Access Compliance Report Public Rights-of-Way (Pedestrian Signals)

Main Street: **OSO_PKWY** Cross Street: **MEANDERING_TRAIL** Location: **SE**

ADA ID: **SGRK211019151627** Signal Type: **One Push Button-APS** Overall Compliance: **No** Severity Scores: **BTN 1: 25** **BTN 2: N/A** **No BTN: N/A**

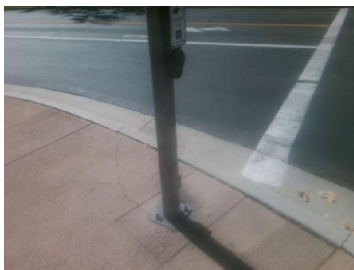
Possible Solutions: Remove and Replace Clear Space.

OC Std/PROW: **R404.2**
